**RE: Application for Proposed Waiver of Waste Discharge Requirements for
Alternative Onsite Wastewater Disposal Systems - 192 & 194 San Remo Road,
Carmel Highlands.**

Exhibit A
Applicant's Responses to Project Opponent's Comments

**SUBJECT: Results of Additional Soil Testing
and Discussion of Potential Influence of Rainfall.**

Exhibit E

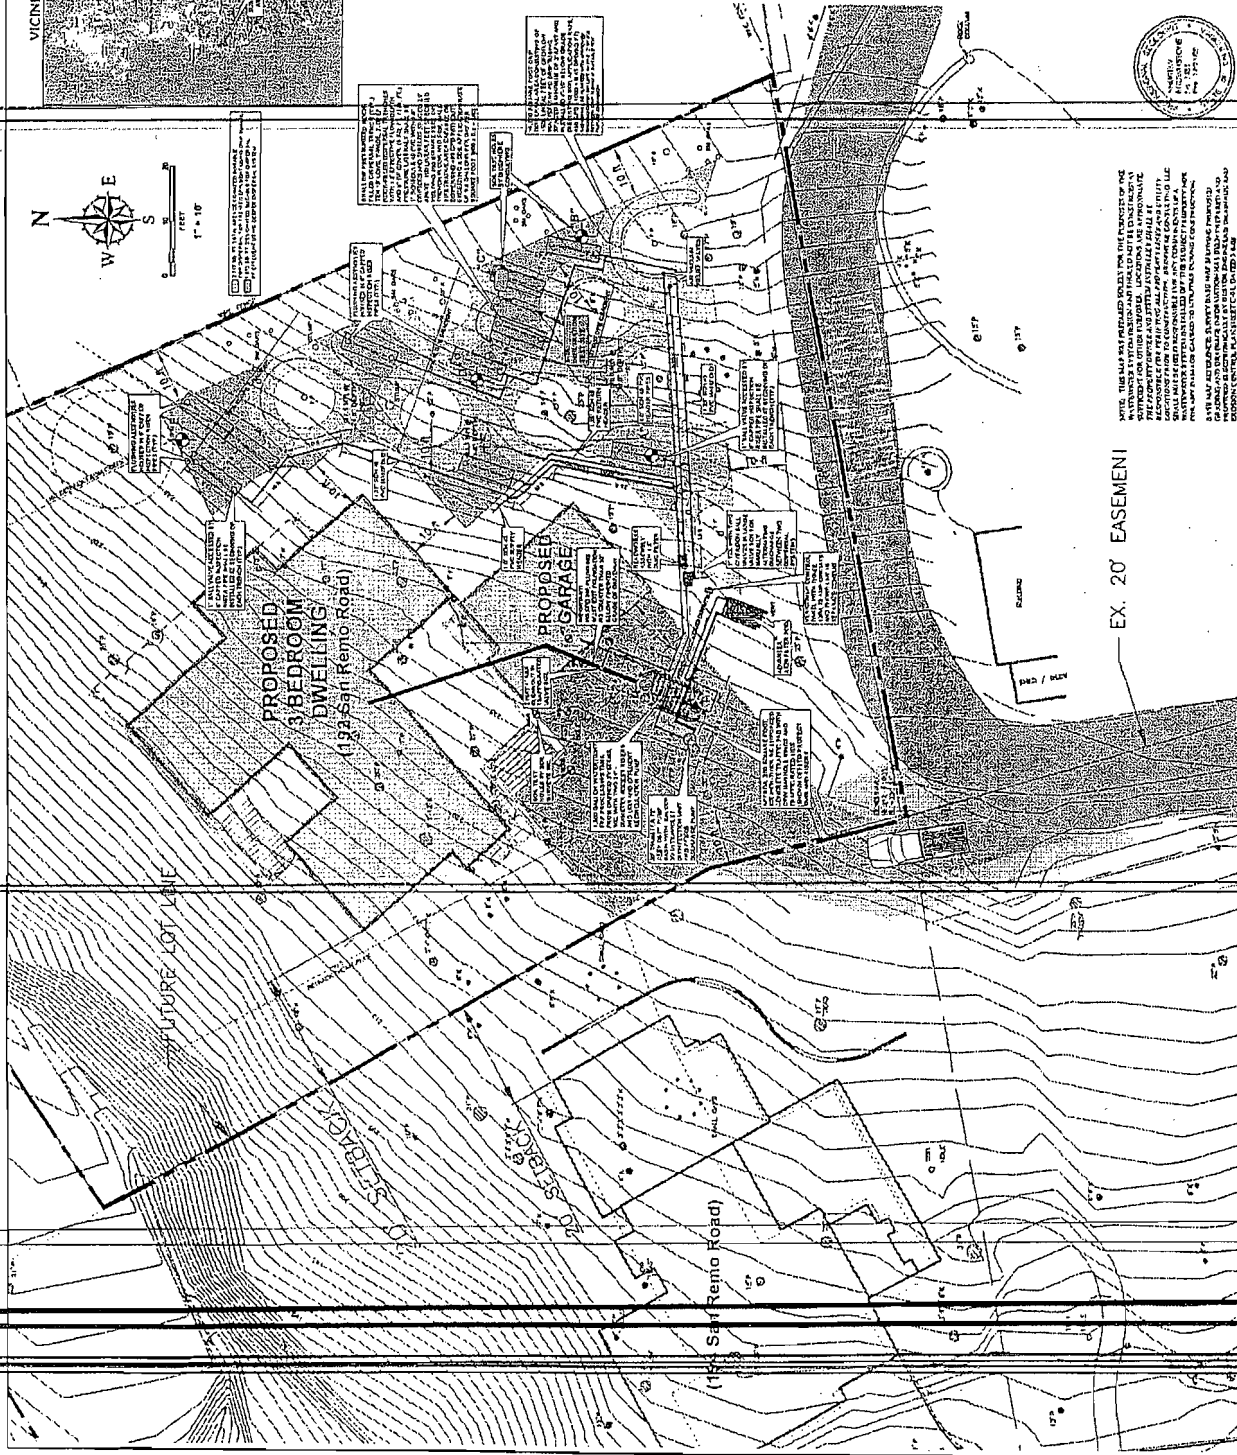
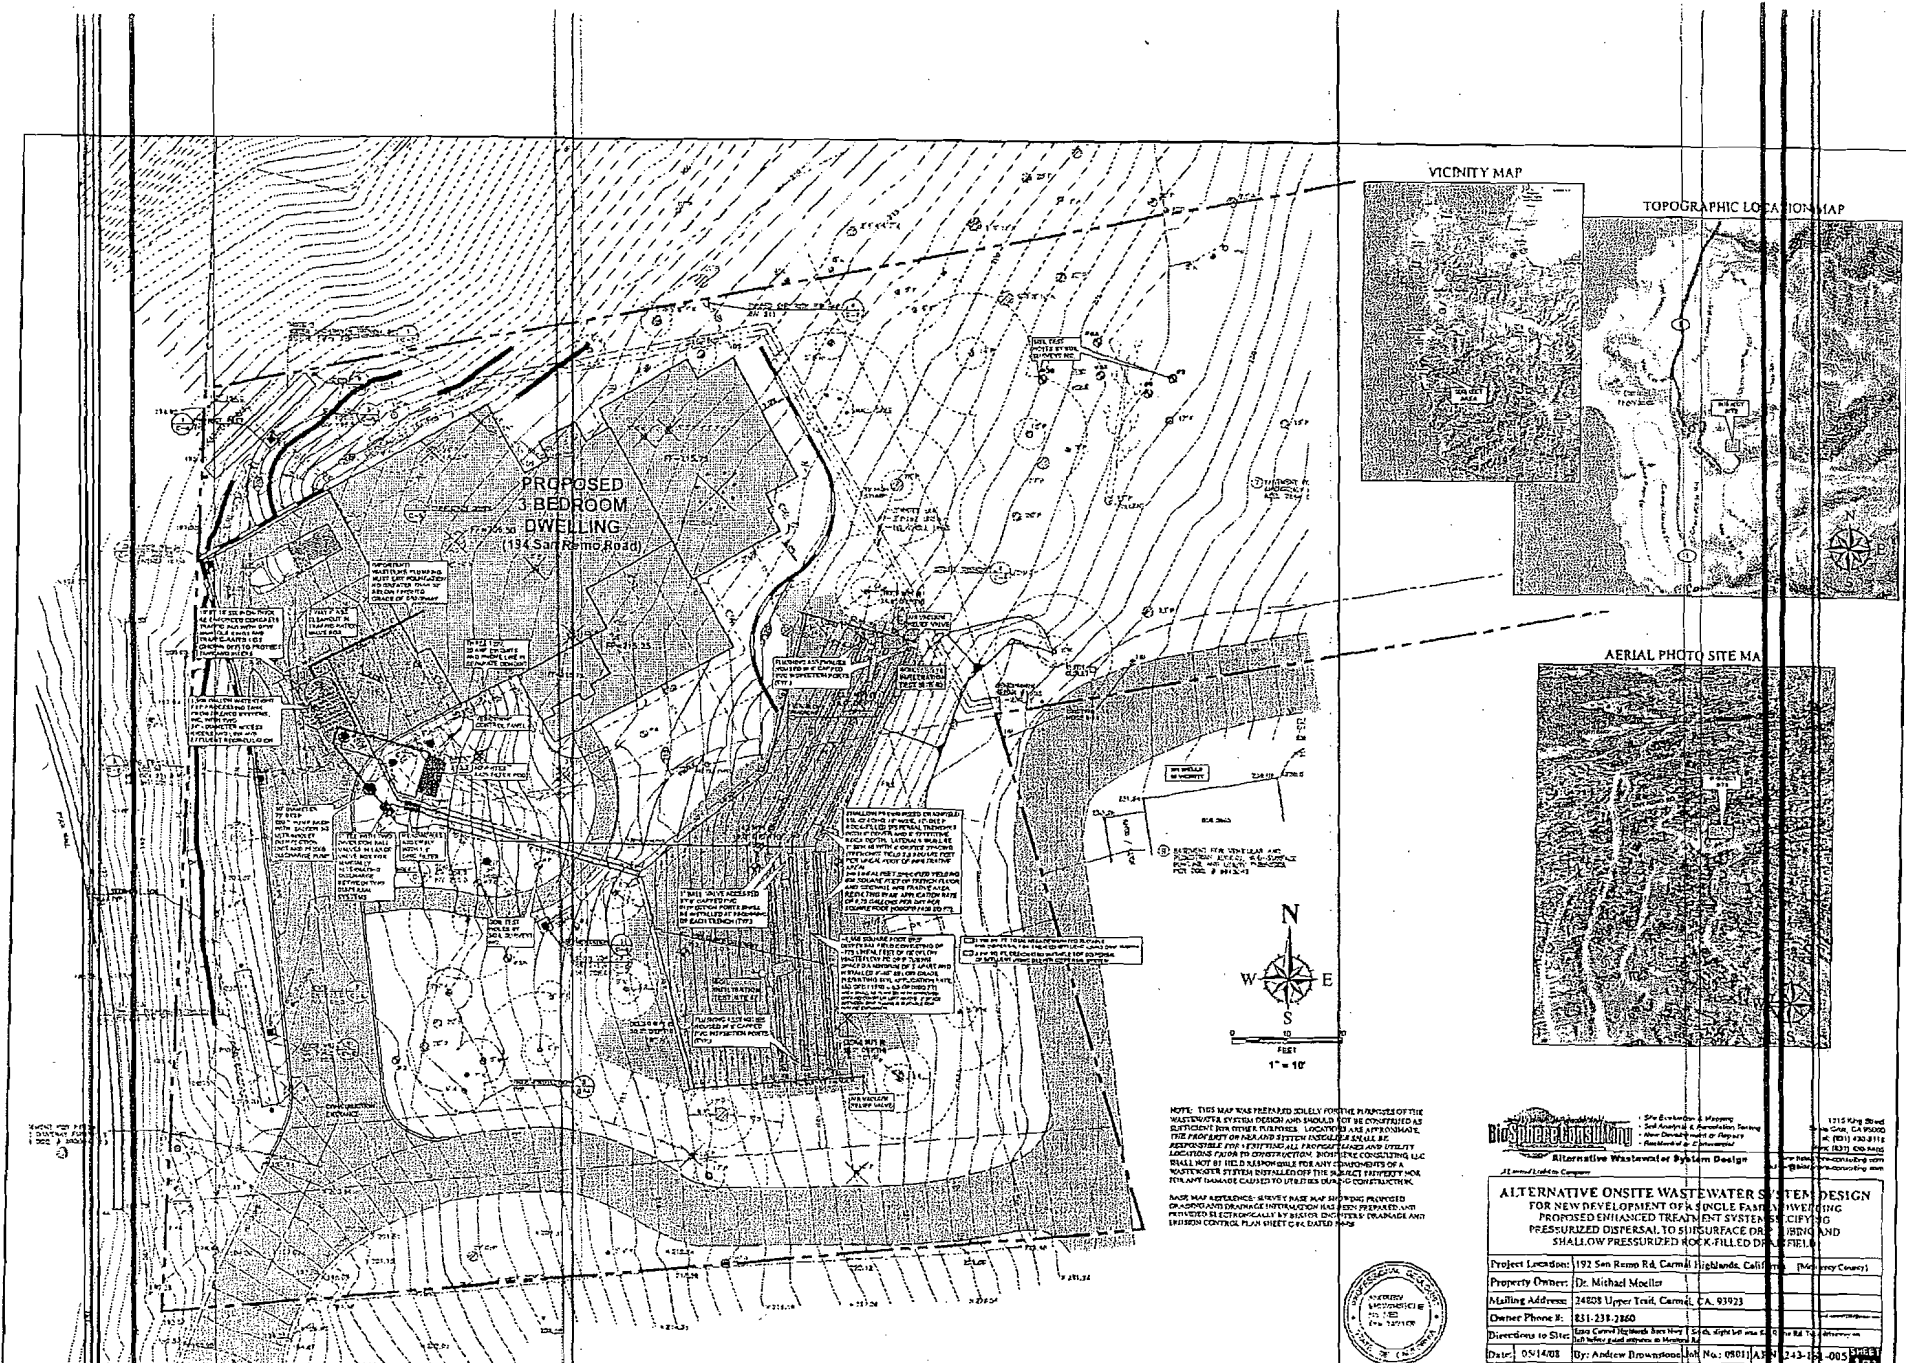
15	<p>Monterey Bay Engineers, Inc.; client – Dr. & Mrs. Hoxie</p>	<p>The plans for parcel -005 show a portion of a private road easement along the southerly boundary as San Remo Road. This property does not have frontage on San Remo Road as the plans would imply.</p>	<p>The commenter is correct. The revised plan is included as Exhibit "E".</p>
16	<p>Monterey Bay Engineers, Inc.; client – Dr. & Mrs. Hoxie</p>	<p>There is a significant conflict between the leach</p>	<p>The commenter is correct. The consultant used the wrong base map for driveway configuration. The corrected, revised plan is included as Exhibit</p>

Comment No.	Commenter	Comment	Response
		field proposed and the driveway for parcel -005.	"E."
17	Leland Lewis	<p>The current configuration of the property, despite its 20 degree slope toward the neighboring property, would provide adequate area for sufficient rock-filled backup dispersal trenches.</p> <p>Reconfiguration of the building site through a lot line adjustment as would nullify the possibility of providing sufficient area for this septic tank.</p>	<p>As discussed in response to Comment No. 14, the applicant has volunteered to conduct a slope stability evaluation by collecting additional data to further evaluate geologic and geotechnical suitability of the leachfield sites. The results of this evaluation will be submitted to staff prior to the RWQCB hearing. The scope of work for the slope stability evaluation is described in Exhibit "C."</p>
18	Leland Lewis	<p>Influence of heavy surface rain inundating the 20-degree slope of the building site trumps ordinances, requirements and compliance.</p>	<p>As discussed in the response to Comment No. 11 and further discussed in the report prepared by BioSphere Consulting (Exhibit "B"), the rain water will further benefit the water quality of the filtrate through dilution and additional cleansing of the soil pores, enhancing the natural microbial degradation. BioSphere Consulting's report also notes that the proposed system is water tight and equipped with an alarm system which will provide immediate notification if there is a leak in the system. Because the proposed dispersal systems will be pressurized, there is little concern that the trenches will be flooded with near-surface water.</p>
